HITACHI SEMICONDUCTOR TECHNICAL UPDATE

| DATE | 8 February 2000 | No. | TN-PLC-350A/E |
| THEME | HD66735 Procedure for setting Standby/Sleep/Display off mode. | | |
| PRODUCT NAME | HD66735 series, HCD66735 series, HWD66735 series | | |

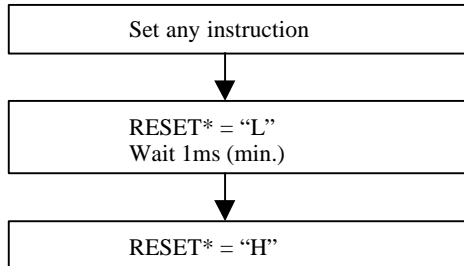
Follow the next procedure when you set standby/sleep/display off mode.

1. Serial interface

i) Standby mode

iii) Display off mode (DC=DS=0)

ii) Sleep mode
